**ADDENDUM NUMBER:** Three (3)  
**DATE:** February 3, 2026  
**PROJECT:** Interior Renovations for Montgomery County Assessor of Property  
**DESIGNER:** DOUGLAS A. JONES, ARCHITECT  
 MONTGOMERY COUNTY ENGINEERING  
**BID OPENING:** February 10, 2026, at 2:00 P.M.

**TO PLANHOLDERS:** This addendum is issued to modify the original Project Manual and Project Drawings dated January 14, 2026, and is hereby made part of the contract documents. Acknowledge receipt of this Addendum in the space provided on the Bid Form. Failure to do so may subject the Bidder to disqualification.

CEILING DEMOLITION PLAN  
INTERIOR RENOVATIONS FOR  
MONTGOMERY COUNTY ASSESSOR OF PROPERTY  
350 PAGEANT LANE, SUITES 401 & 402  
CLARKSVILLE, TENNESSEE

**A2.1**

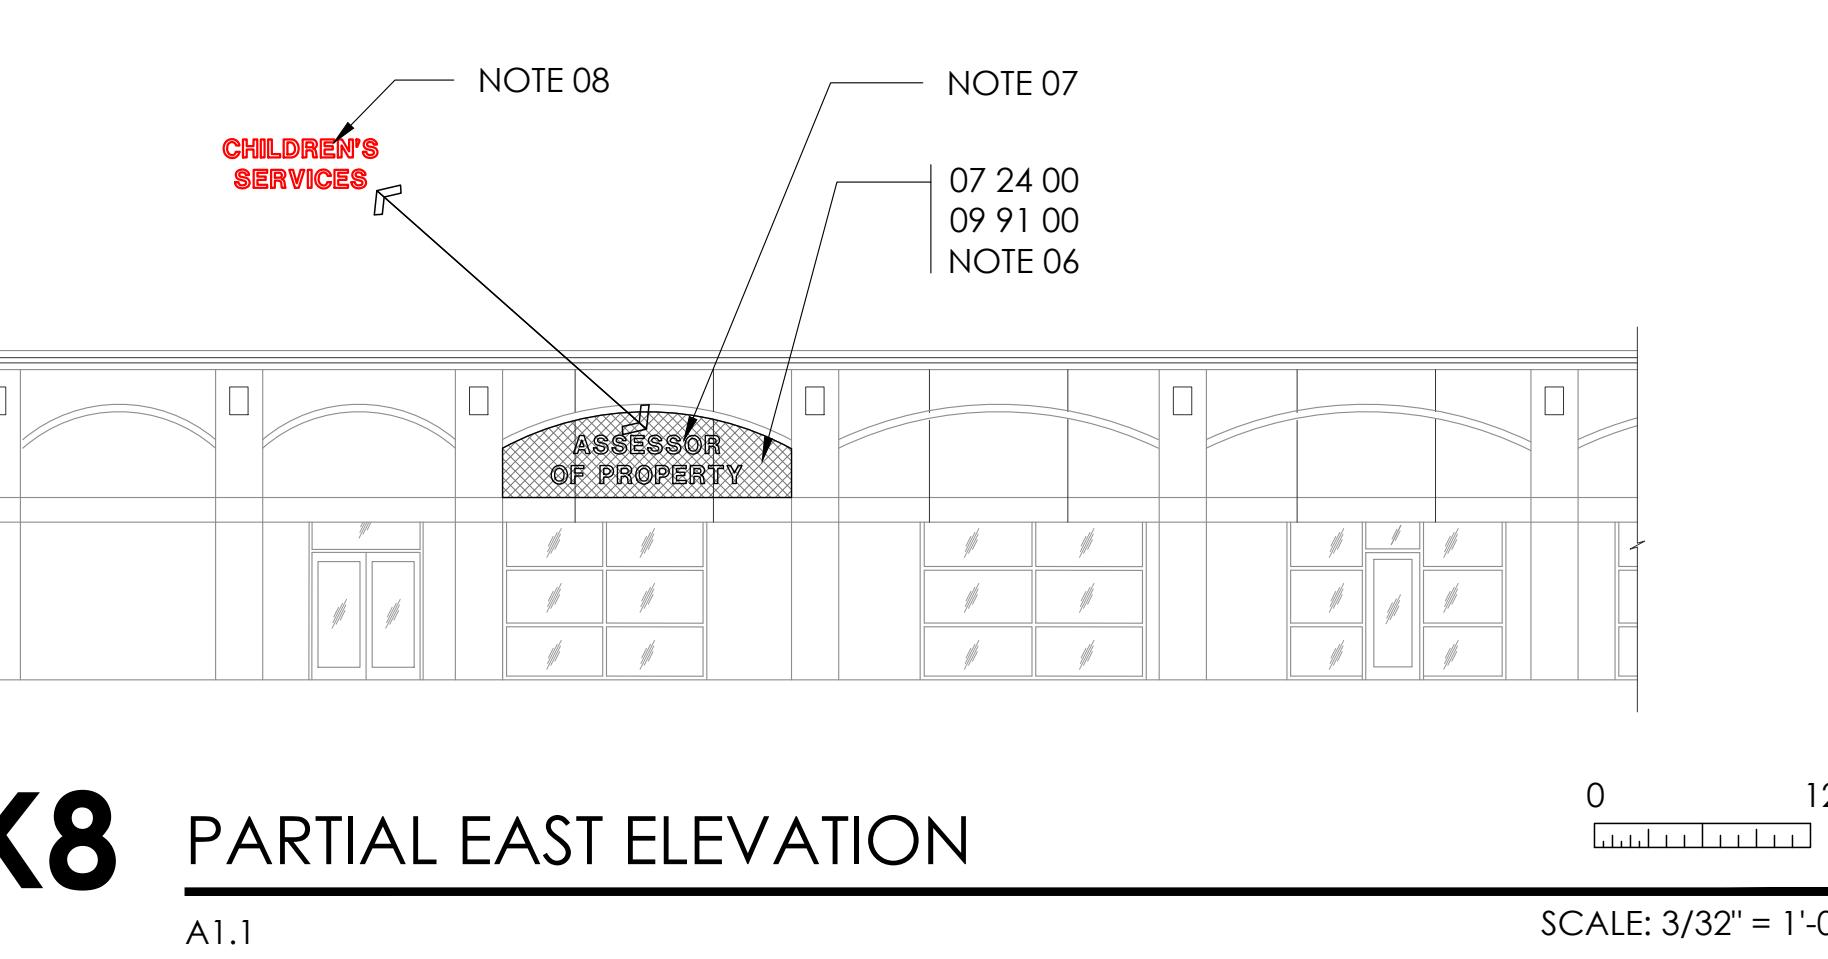
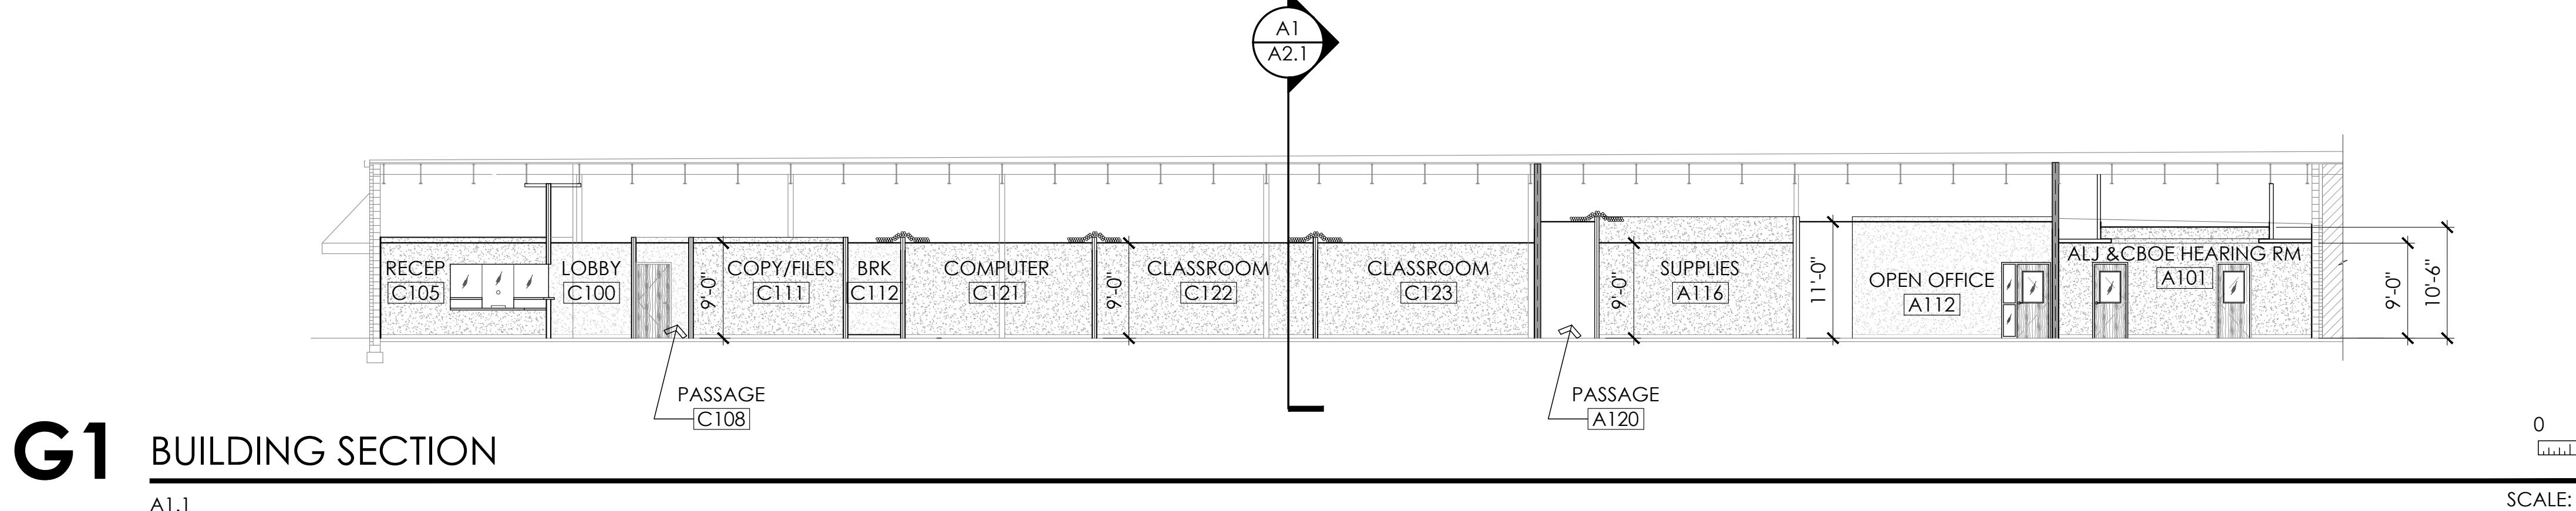
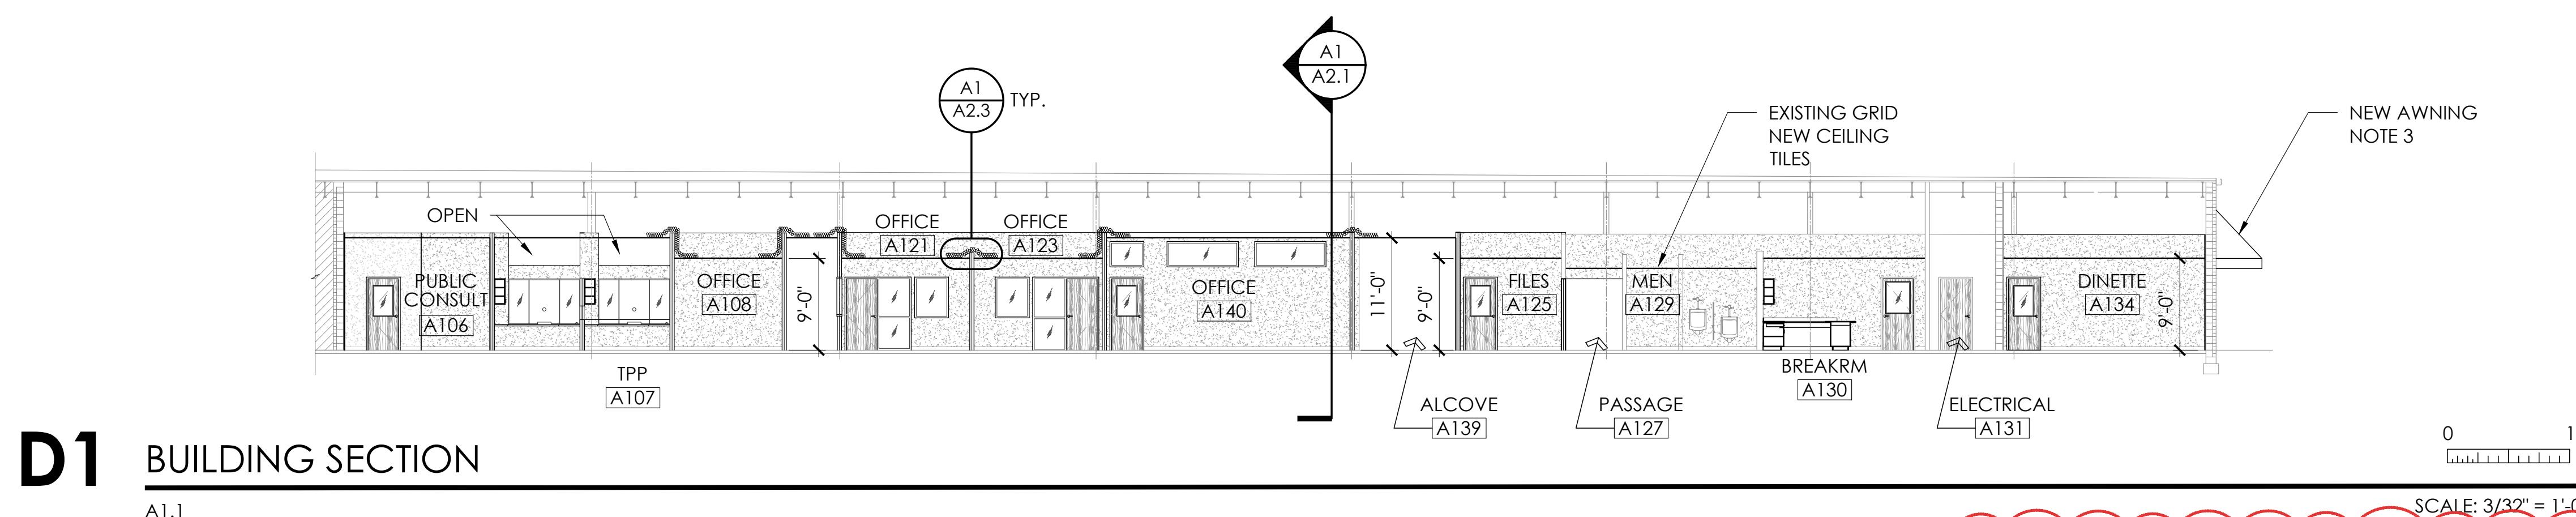
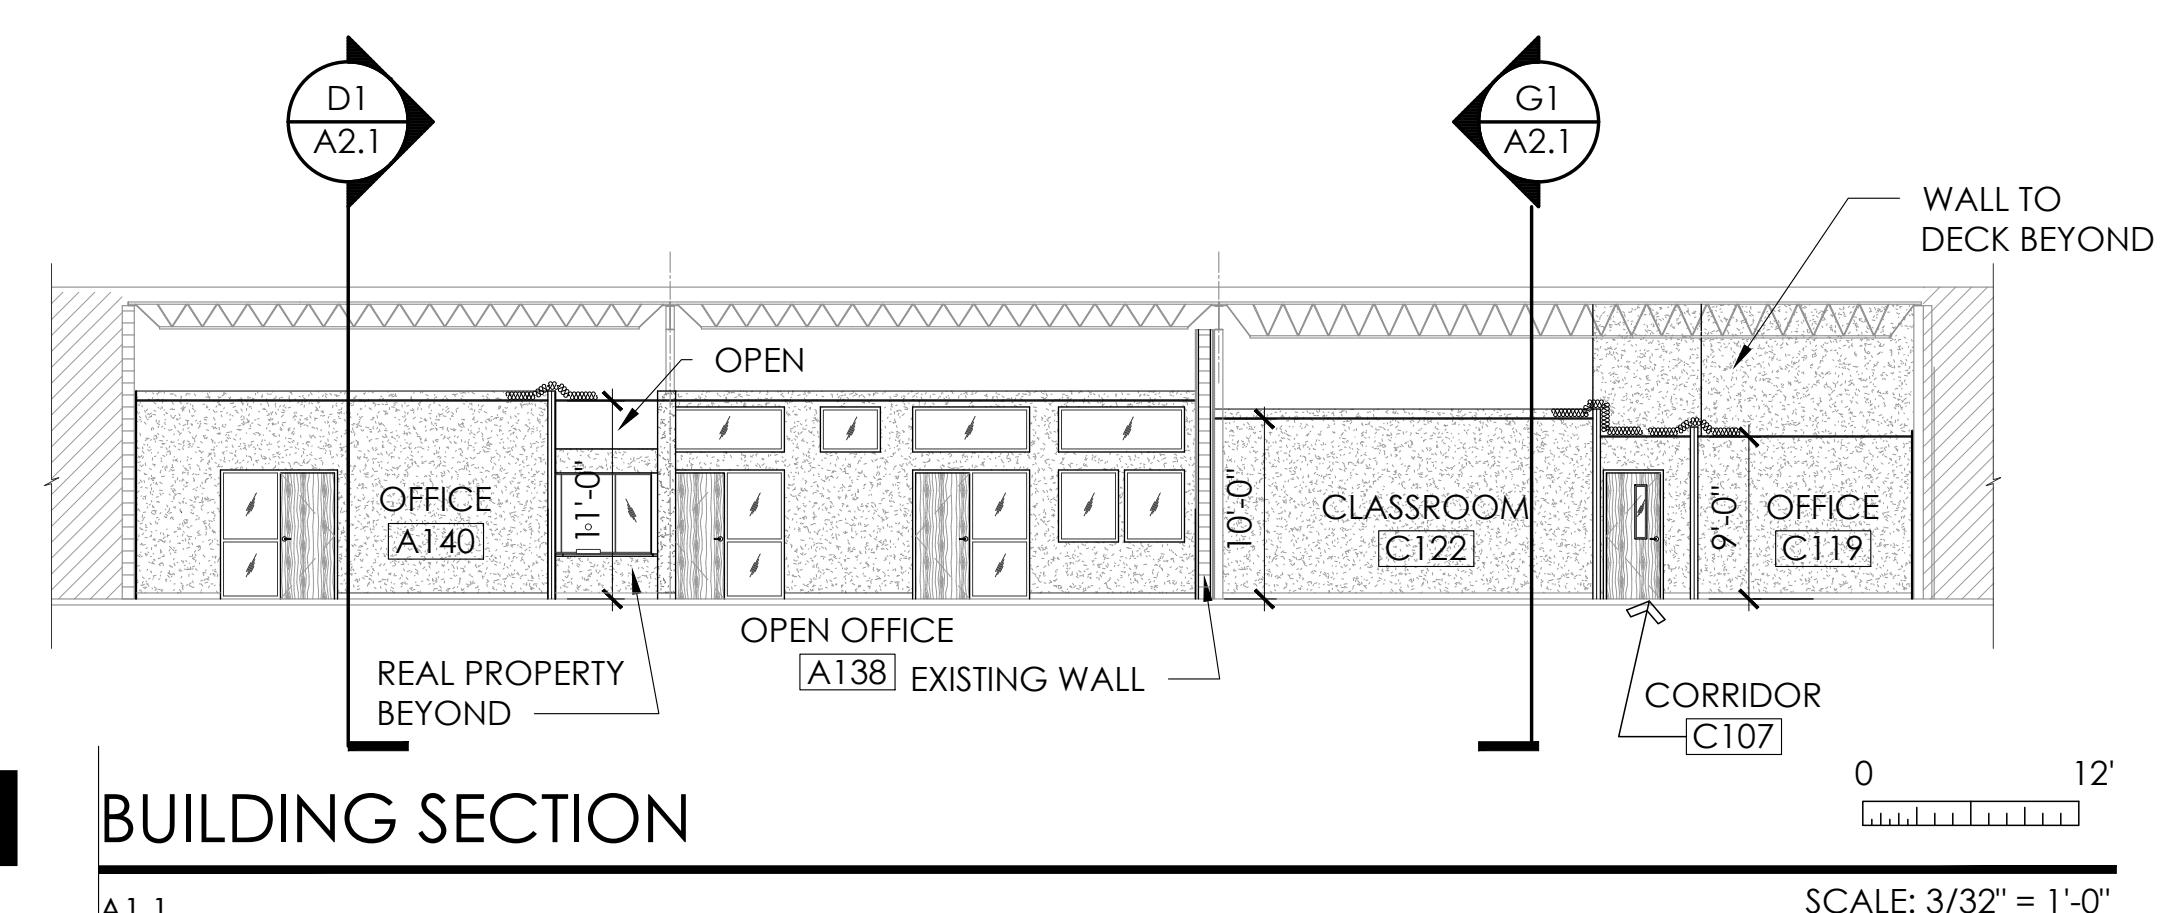
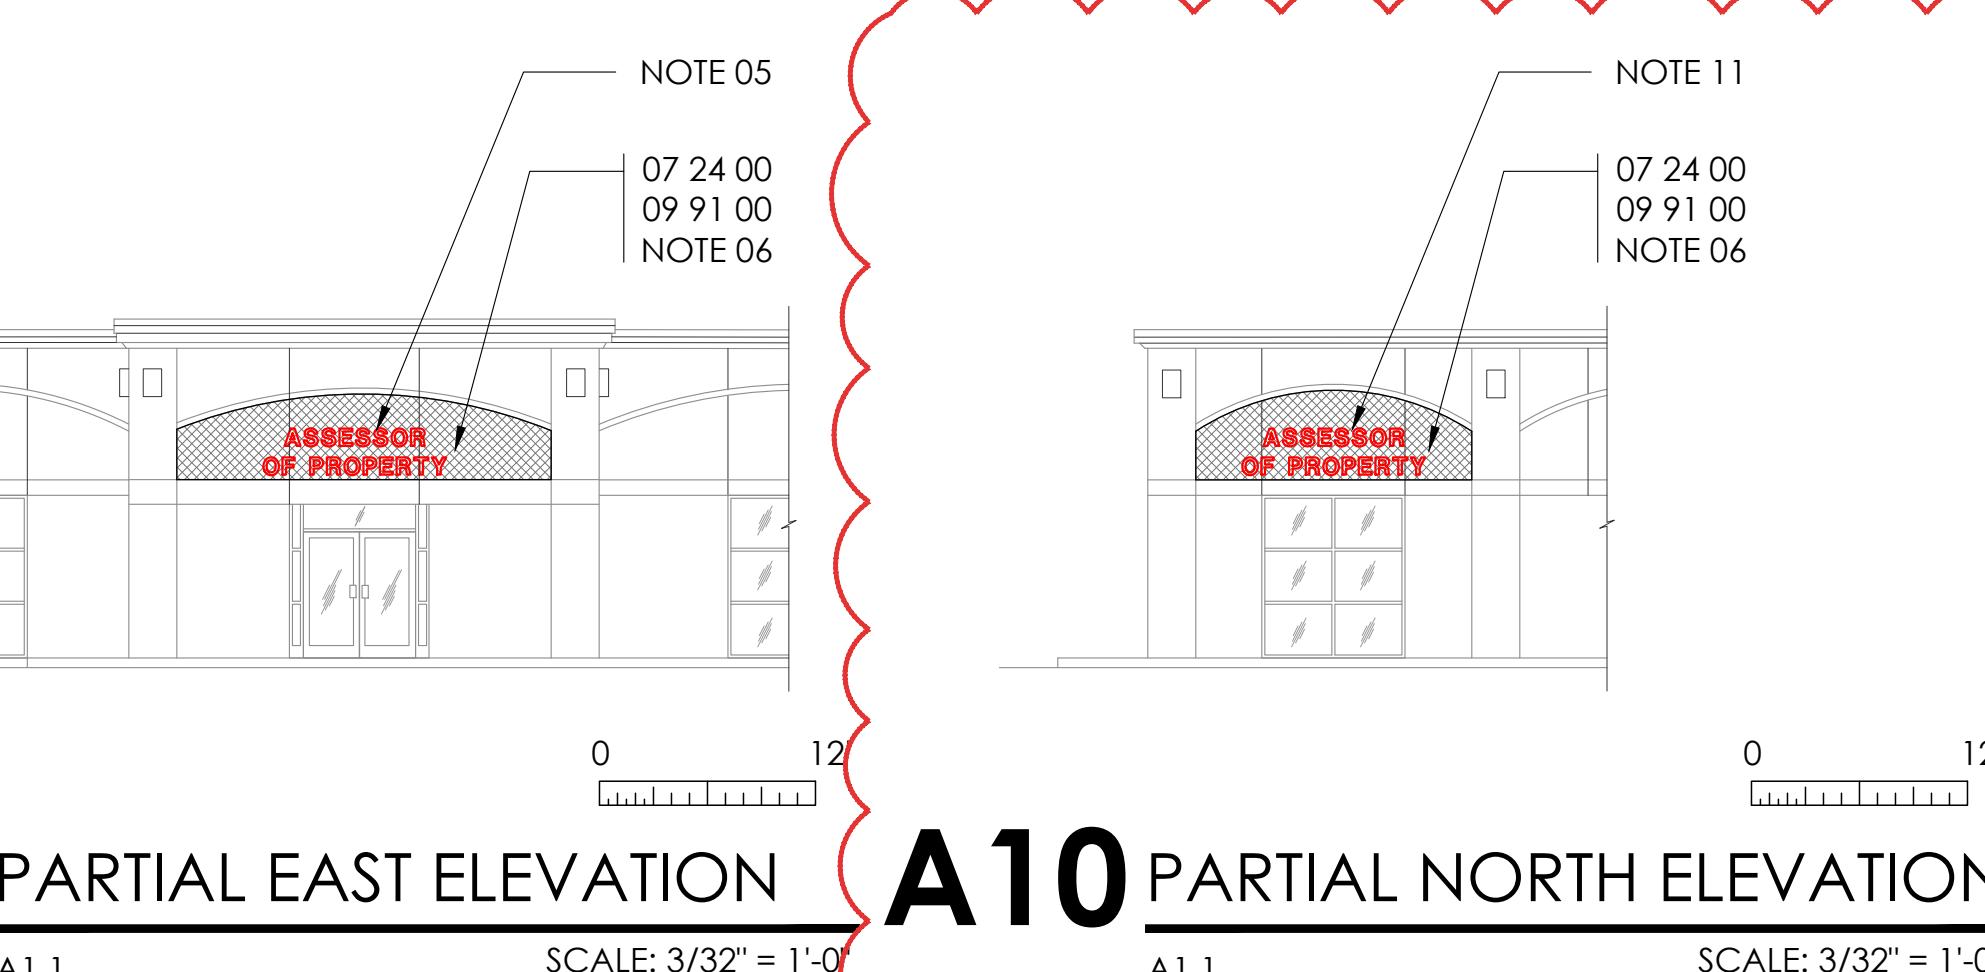
SHEET A2.1 BUILDING ELEVATIONS & SECTIONS; Delete Sheet A2.1 dated 01/14/2026 and Substitute Therefor Sheet A2.1 Dated 2/3/2026 attached hereto.

Clarification: Additional signage removal & EIFS repair have been added.
